Amphenol InfoCom Europe

Product change notice

Customer		CP/N	T816XXXXXXXX02CEU (long latch header)			
P/N	T816XXXXXXXX02CEU (long latch header)	Date	2021/Sep/06			
Change reason	Due to structure of latch, previous body of long latch and short latch are from different mold that caused no efficiency. In order to optimize product management, we opened new mold for long latch to fit the body. The identical body will improve efficiency and avoid higher cost on production and stock.					
Latch comparison:	1.The old latch open angle is 127.876°/127.603°, the new one is 136.621°/137.960°. Latch open angle is bigger, assembling with IDC socket is more smoothly.					
	<div><div>Old Latch</div><div>New Latch</div></div>

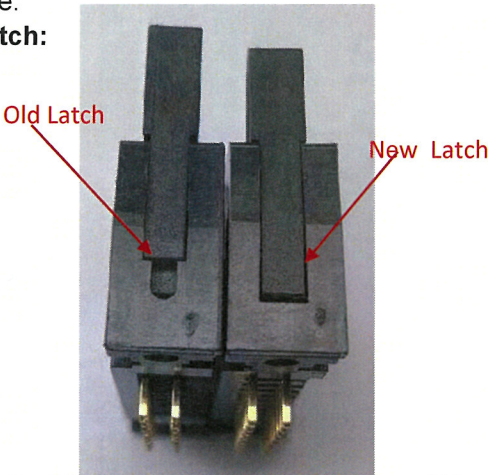
2. Resistance test for new long latch					
	<div><div>Pushing the latch until it is out of position.</div></div>					
	3. Test results: The resistance force of new long latch is higher than 100N.					
	Sample 1#	Sample 2#	Sample 3#	Sample 4#	Sample 5#	Sample 6#
Pushing force(N)	128.4	124.9	136.6	116	120.3	116.7
Maxi	136.6					
Mini	116					
Avrg	123.82					
SDev	7.87

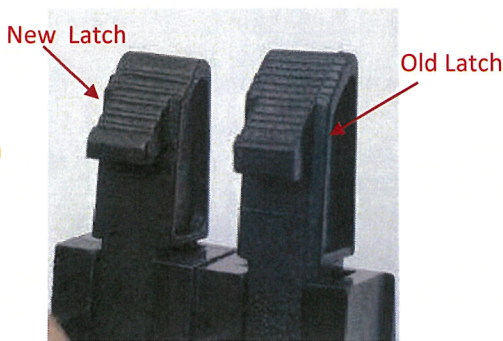
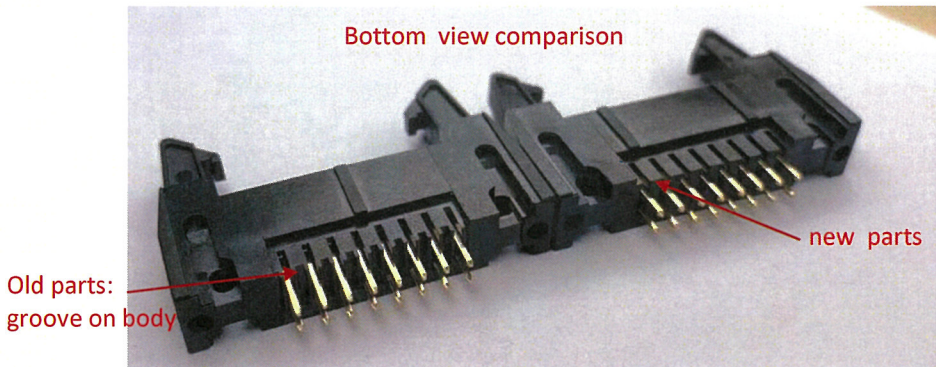
Customer		CP/N	T816XXXXXXXX02CEU (long latch header)
P/N	T816XXXXXXXX02CEU (long latch header)	Date	2021/Sep/06
Latch comparison:	4.The below pictures are obviously different aspect between old latch header and new one.		
	<div><div><p>Latch:</p></div><div></div></div> <div><p>Body: The body of long latch header will be the same as short latch header, there is no groove anymore in long latch header.</p></div>		
Comment	The new long latch header can repalce old one and the function is consistent.		
Approved by: Vincent checked by: Henry Prepared by: Tony
